PRODUCT/PROCESS CHANGE NOTICE (PCN)

PCN #: TB-0510-05 DATE: 14-Dec-2005 Product Affected: 48L, 56L, 64L TSSOP & 80L TVSOP & 48L, 56L TSSOP exposed pad (Green & Standard) Date Effective: 13-Jan-2006	MEANS OF DISTINGUISHING CHANGED DEVICES: <input type="checkbox"/> Product Mark <input type="checkbox"/> Back Mark <input type="checkbox"/> Date Code <input checked="" type="checkbox"/> Other Rev 07 printed on shipping tube
---	--

ATTACHMENT I - PCN #: TB-0510-05

Existing Shipping Tube

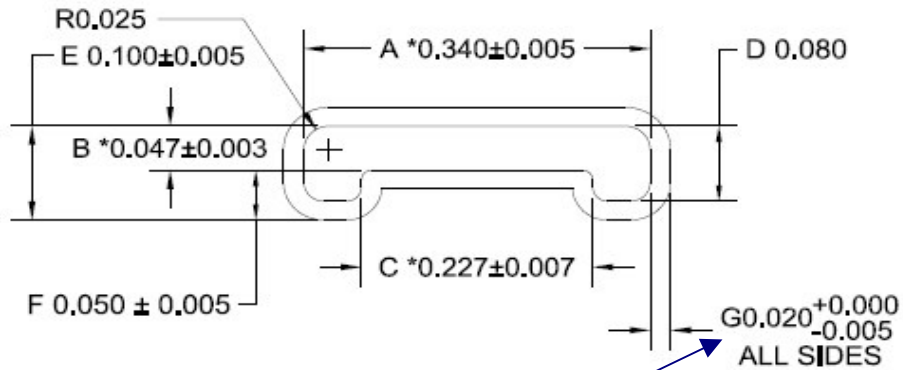
Existing Tube – wall thickness : 0.015 to 0.020

Existing Tube – printed revision, REV.06

New Shipping Tube

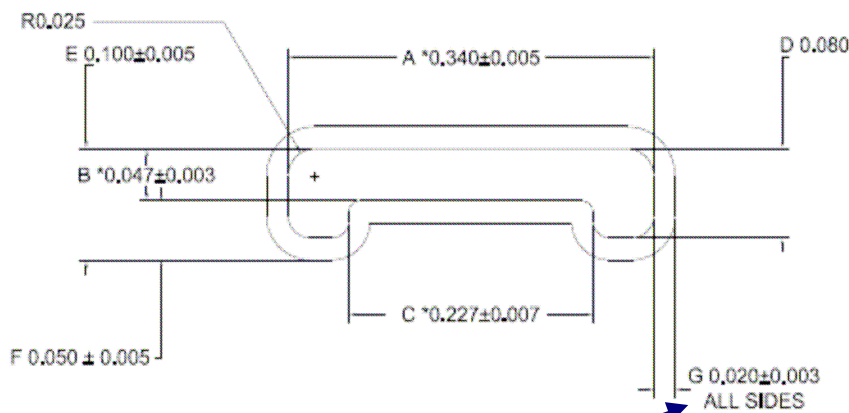
New Tube – wall thickness : 0.017 to 0.023

New Tube – printed revision, REV.07
